ADDENDUM NO. 1 TO BID FORMS

**CORONA-NORCO UNIFIED SCHOOL DISTRICT
PURCHASING DEPARTMENT
Bid No. 2023/24-204**

CORONA FUNDAMENTAL INTERMEDIATE SCHOOL MPR MODERNIZATION

SHEET NO.:
A-110

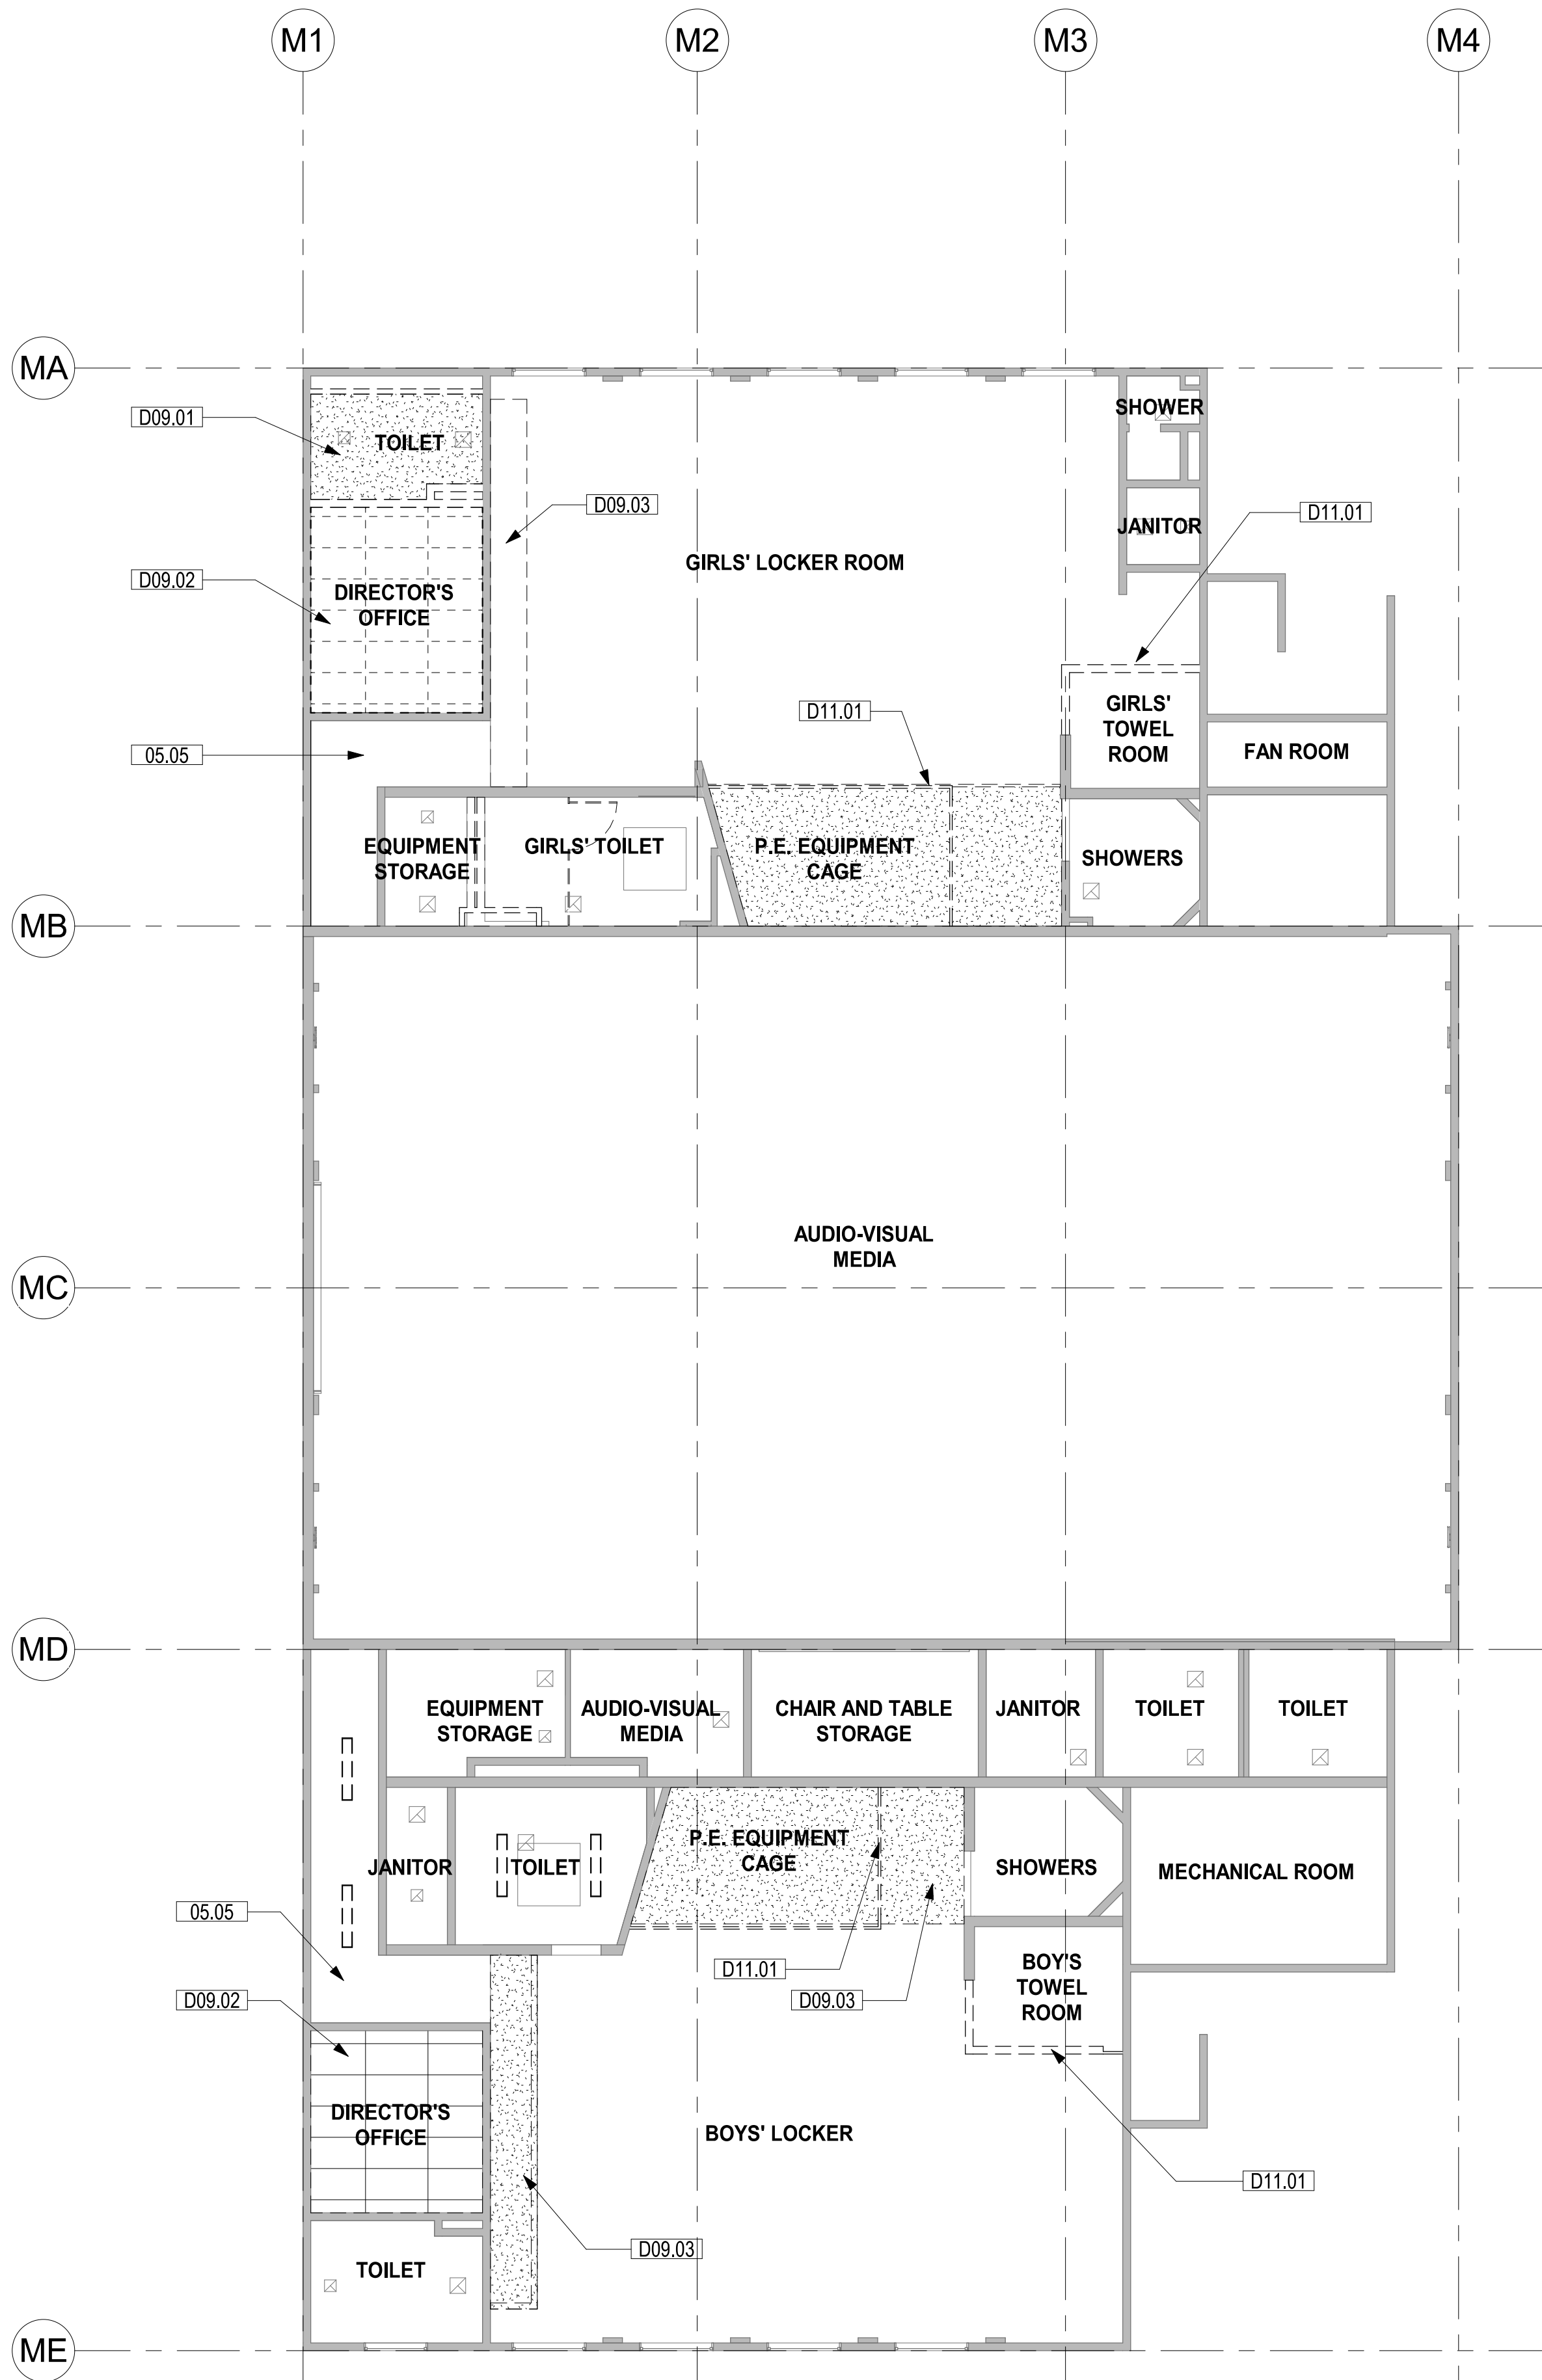
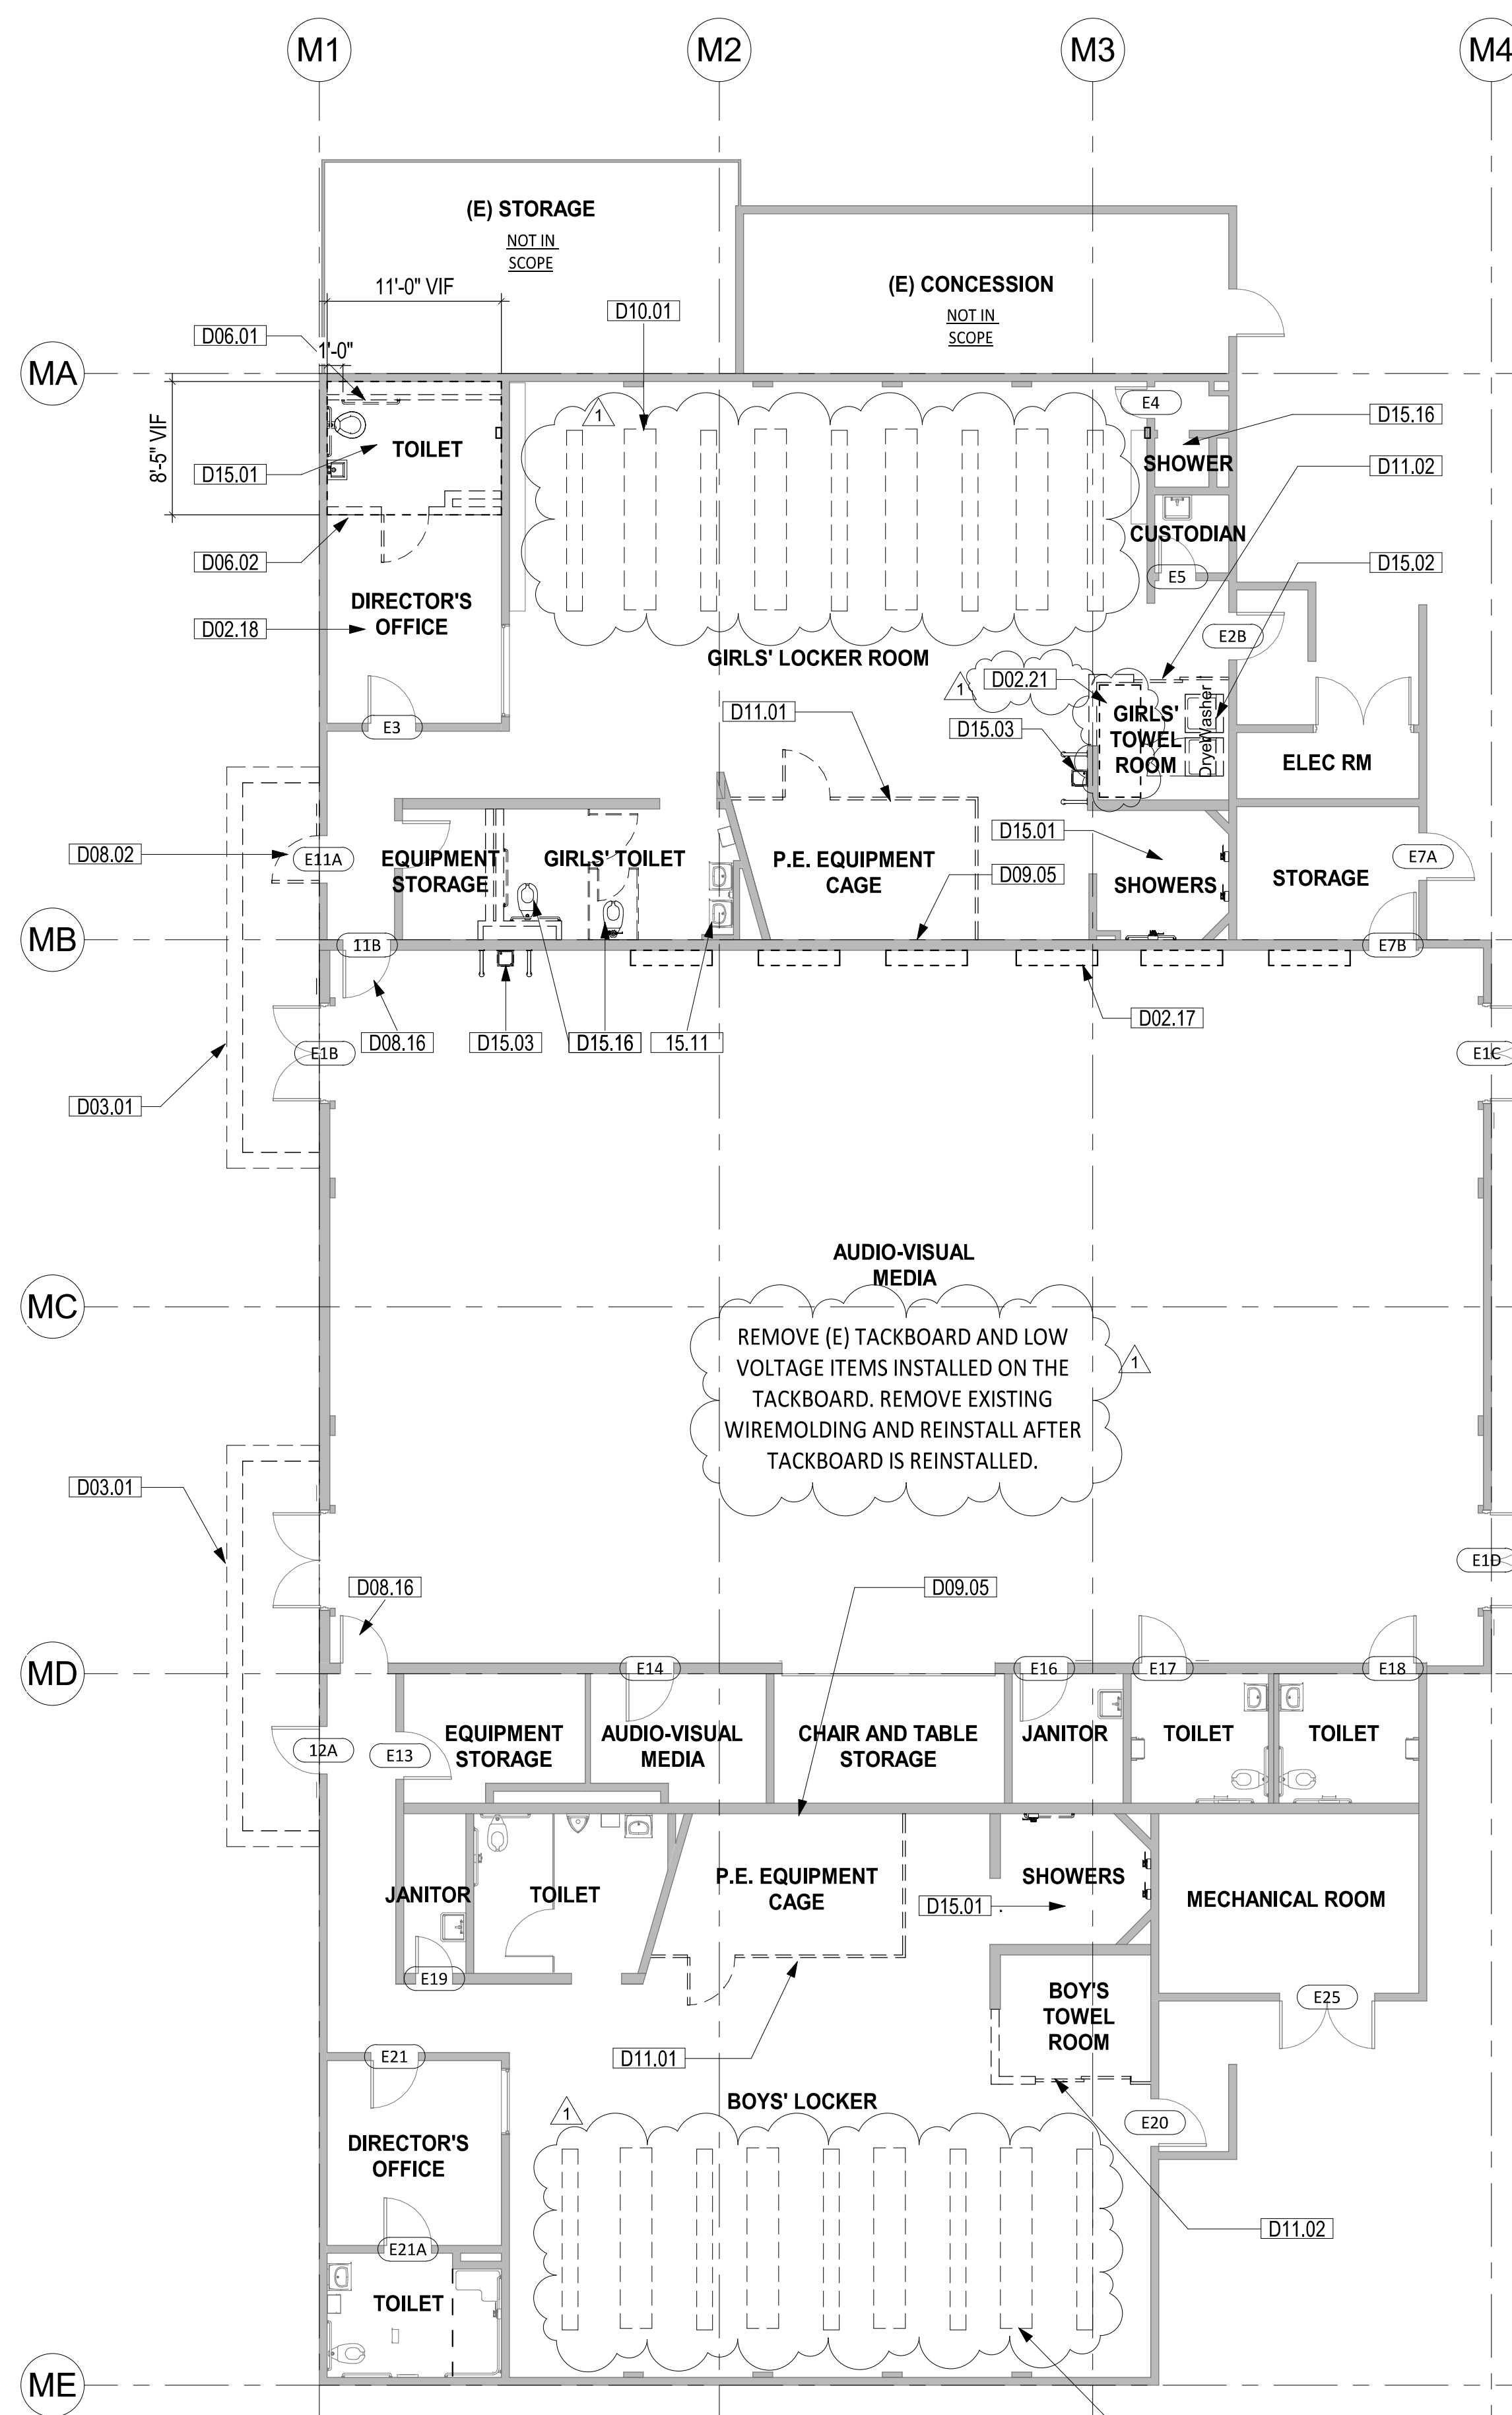
Item No. 1.03
A-110 - 1ST FLOOR PLAN & RCP - OVERALL – DEMO

- Sheet note 12 removed
- Existing lockers to be demolished shown in Boys' and Girls' locker rooms
- Existing tabletop & cabinet to be demolished shown and keynoted in Girl's Towel Room
- Note in Audio-Visual Room revised
- Note added to Boys' Towel Room regarding existing tile
- Keynote D02.21 added for tabletop & cabinet
- Keynote D10.01 revised
